**PARKSIDE TOWNHOMES**  
 RAMSEY, MINNESOTA  
**LANDSCAPE LAYOUT PLAN**  
 FOR  
**COR AT RAMSEY LLC**  
 3313 LAKESHORE COURT, CHASKA, MN 55318

**PARKSIDE TOWNHOMES**  
 RAMSEY, MINNESOTA  
**LANDSCAPE DETAILS**  
 FOR  
**COR AT RAMSEY LLC**  
 3313 LAKESHORE COURT, CHASKA, MN 55318

## 1 - River Birch

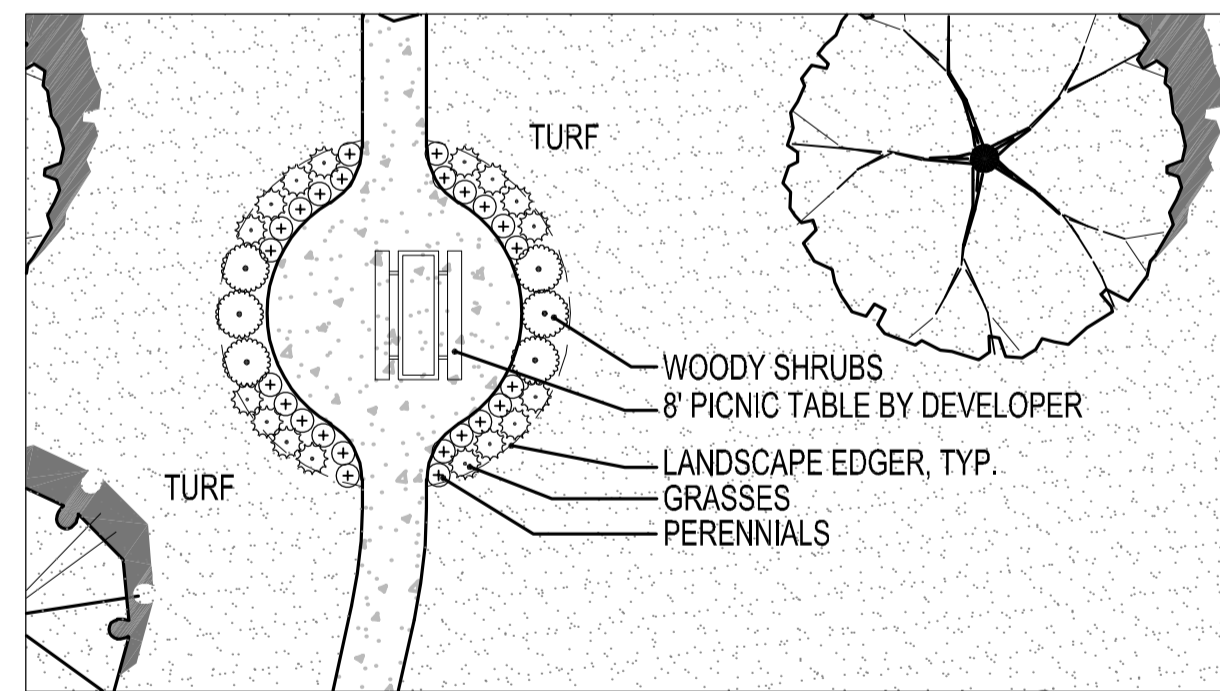
River Birch is acceptable in boulevard areas but it MUST be single stem. No clump plantings in the boulevard will be permitted. The clump form is acceptable for any plantings internal to the site. Please add note to Plant Schedule.
